ADDENDUM NO. 1

October 13, 2021

UNION DECK ELEVATOR REPLACEMENT
UNC CHARLOTTE

WHN PROJECT NO. 20142 | SCO ID NO. 20-2231

ELECTRICAL POWER PLAN NEW WORK

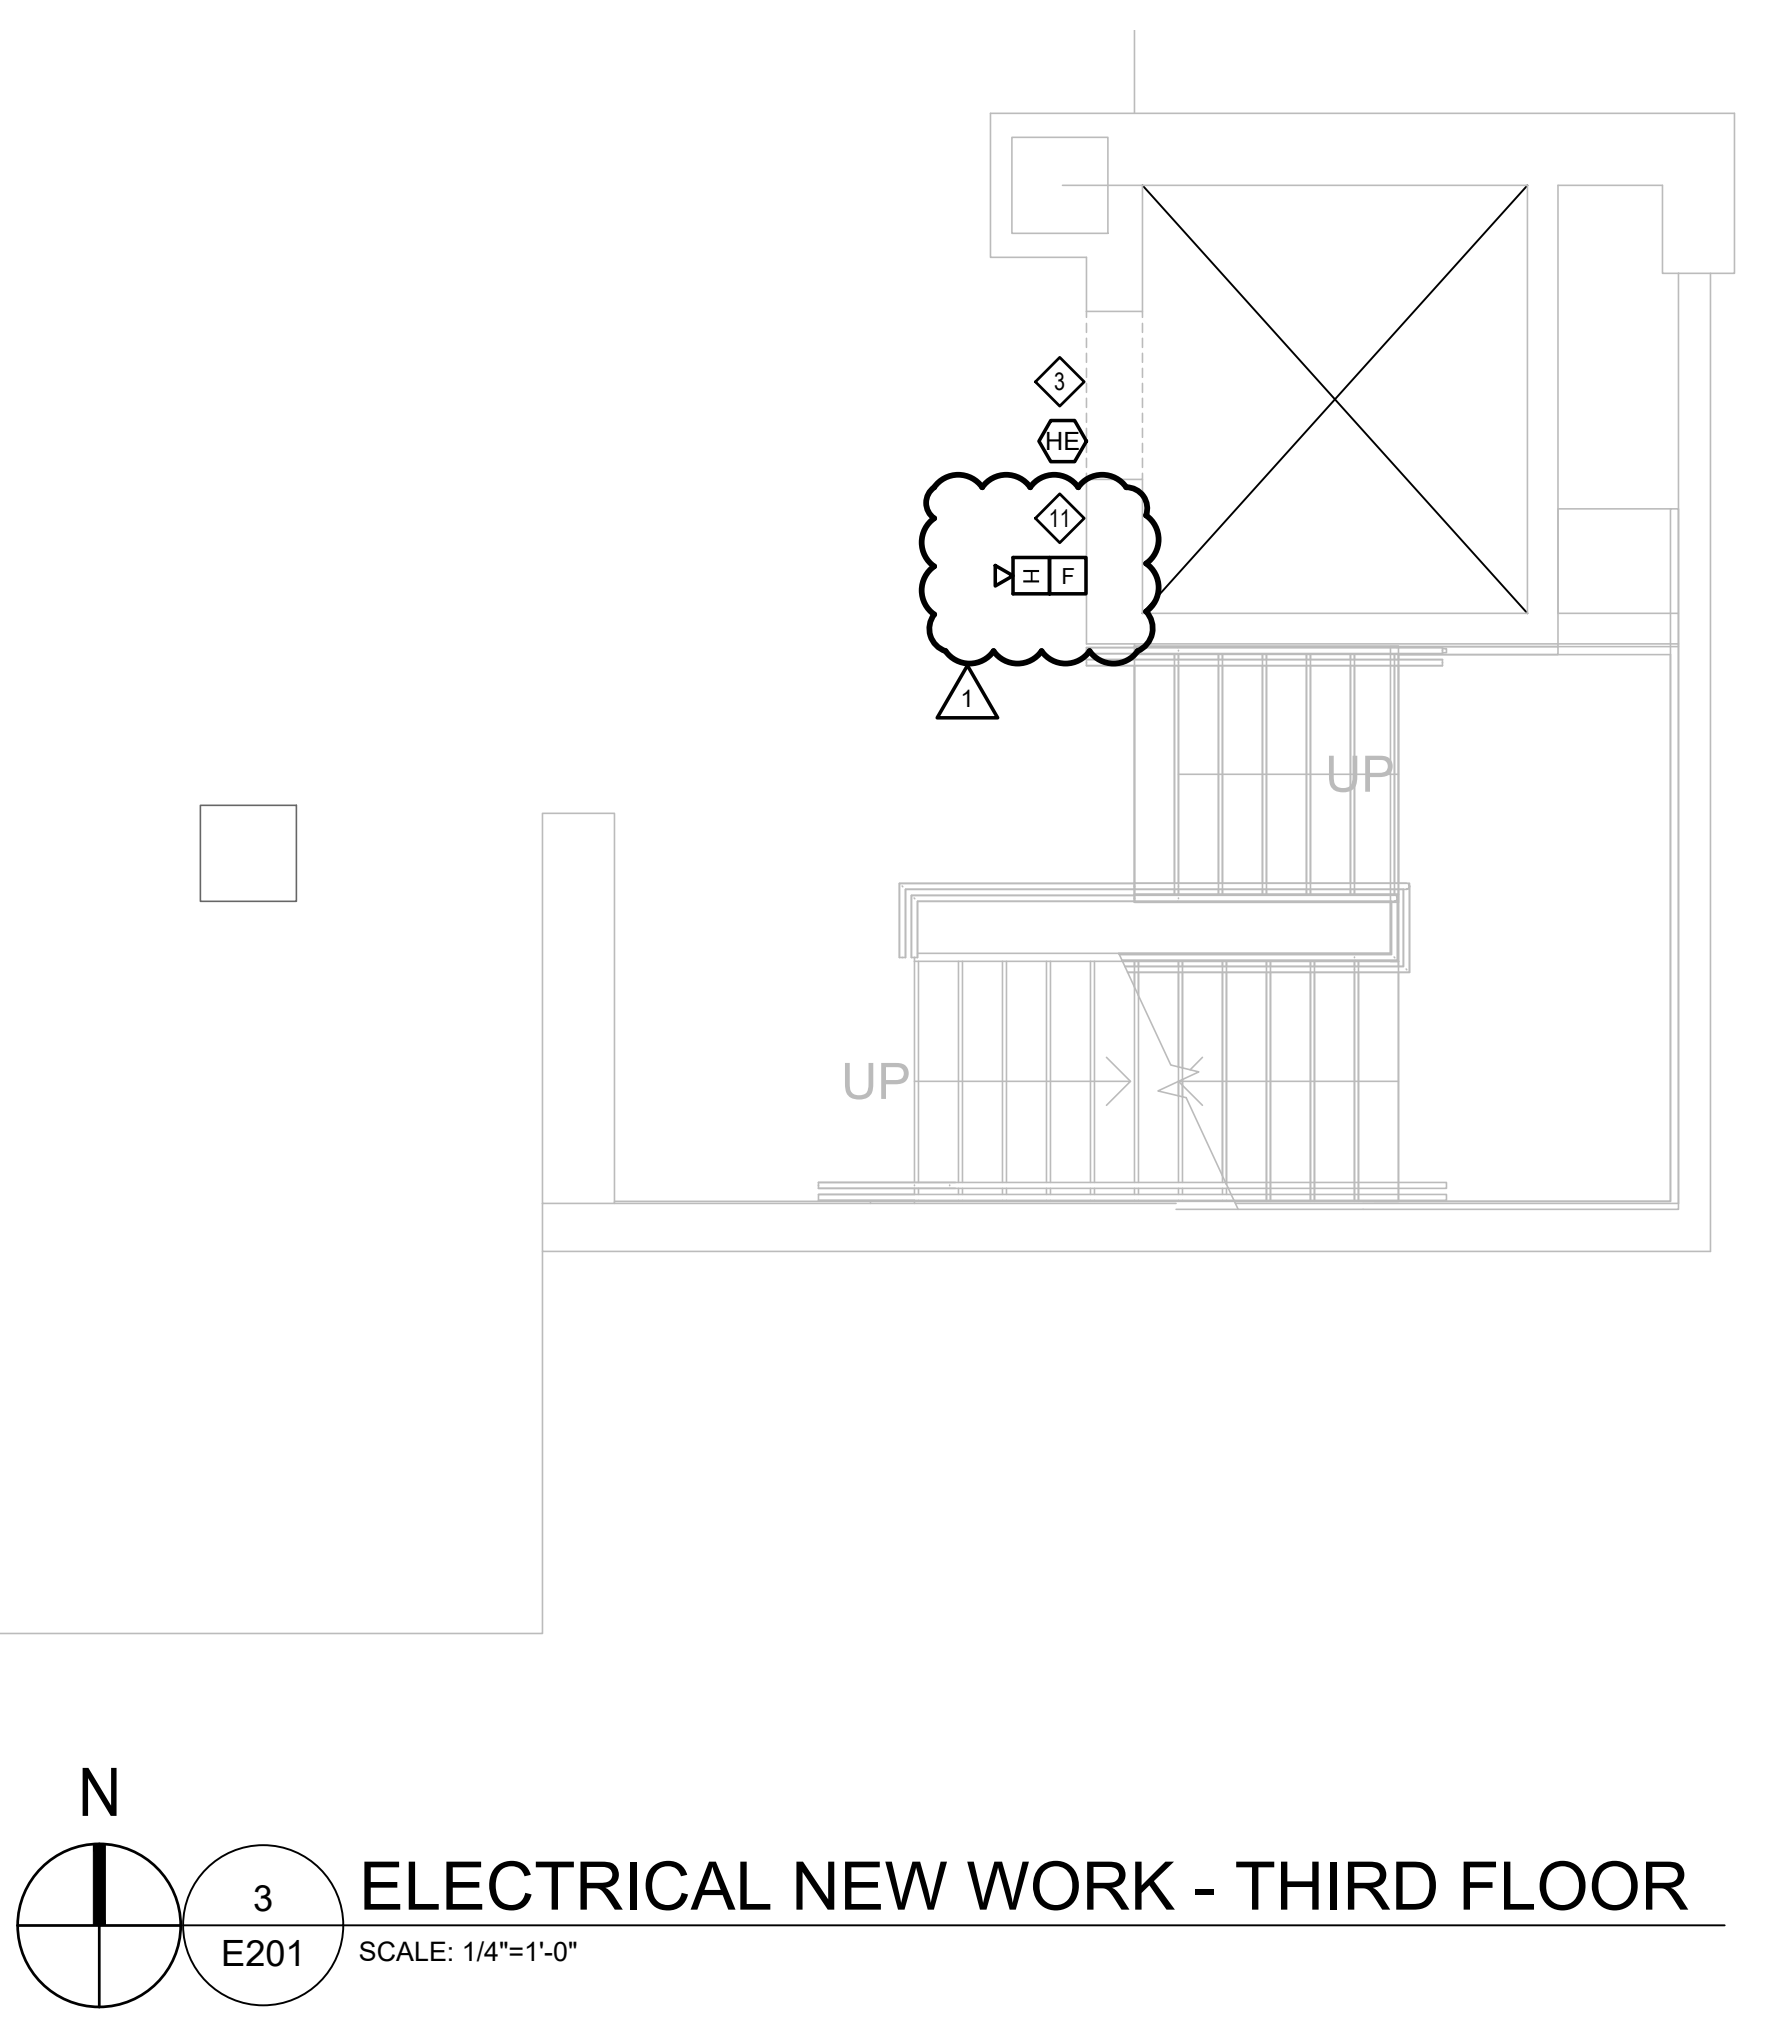
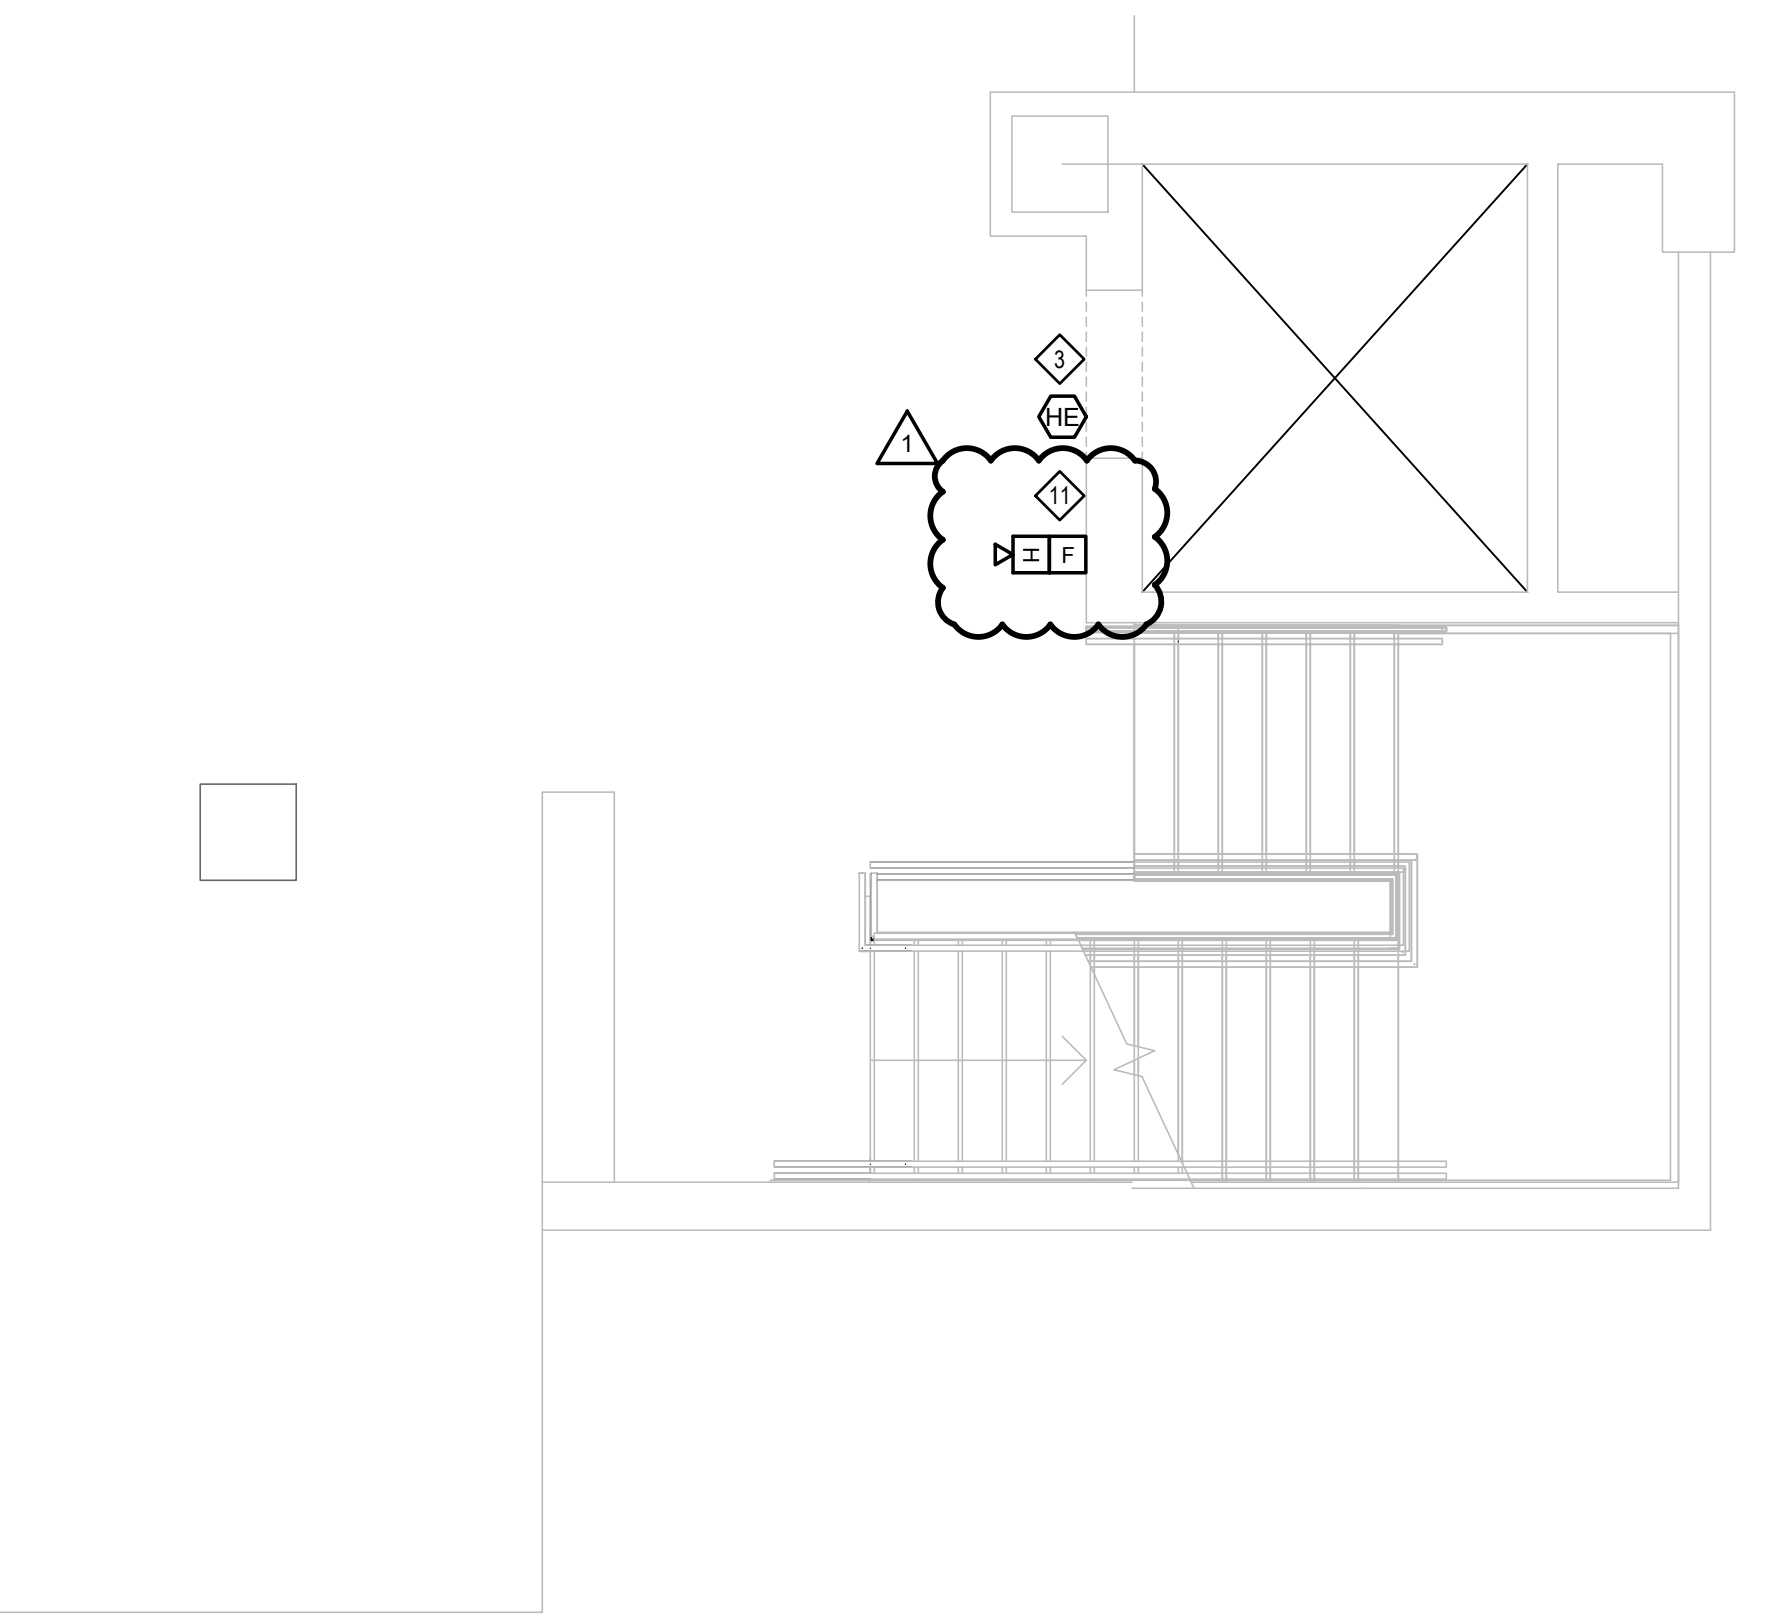
- CONFIRM EXISTING RECEPTACLE IS A GFI TYPE OR PROVIDE NEW GFI RECEPTACLE.
- PROVIDE NEW HEAT DETECTOR MOUNT IN PLINTH ABOVE PIT FLOOR.
- PROVIDE NEW HEAT DETECTOR FOR ELEVATOR RECALL.

- INDOOR UNIT IN ELEVATOR EQUIPMENT ROOM TO BE CONNECTED TO OUTDOOR CONDENSOR UNIT. WIRING AND DISCONNECTS TO BE PROVIDED AS DESCRIBED IN DETAIL 5E301.

- PROVIDE 2 DATA LINES TO ELEVATOR CONTROLS: ONE FOR VOIP COMMUNICATIONS AND ONE FOR VIDEO COMMUNICATIONS.
- PROVIDE NEW 100A/3P SHUNT TRIP CIRCUIT BREAKER WITH AUXILIARY CONTACTS THAT MEETS ELEVATOR CODE REQUIREMENTS. TWO SETS OF AUXILIARY CONTACTS SHALL BE PROVIDED. ONE SET OF CONTACTS ARE USED TO SHUNT TRIP CIRCUIT BREAKER WHEN ACTIVATED BY FIRE ALARM SYSTEM. SHUNT TRIP ACTIVATION MUST BE DELAYED BY MINIMUM OF 60 SECONDS AFTER FIRE ALARM ACTIVATION. SECOND SET OF CONTACTS ARE USED TO PREVENT ELEVATOR BATTERY LOWERING OPERATION FROM FUNCTIONING WHEN THE DISCONNECT IS IN THE OFF POSITION PER ELEVATOR SPECIFICATIONS. IF EXISTING ELEVATOR DISCONNECT HAS THESE FEATURES BUILT INTO THE DEVICE, THEN IT DOES NOT HAVE TO BE REPLACED.

- PROVIDE NEW SIMPLY 410ES CPU IN EXISTING FIRE ALARM CONTROL PANEL THAT IS COMPATIBLE WITH NEW AND EXISTING FIRE ALARM DEVICES.
- COORDINATE DATA CABLES WITH ELEVATOR EQUIPMENT VENDOR. FOUR (4) DATA CABLES TO BE PROVIDED BETWEEN TELECOM ROOM AND THE ELEVATOR CAB FOR OWNER SECURITY DEVICES. ELEVATOR VENDOR TO PROVIDE DATA AND VOIP BETWEEN THE ELEVATOR CONTROLS AND THE ELEVATOR CAB TO PROVIDE VOICE AND VIDEO IN THE CAB AS REQUIRED BY THE ELEVATOR CODE, ASME A17.1-2019.

- EXISTING FIRE ALARM DEVICES TO REMAIN IN PLACE.
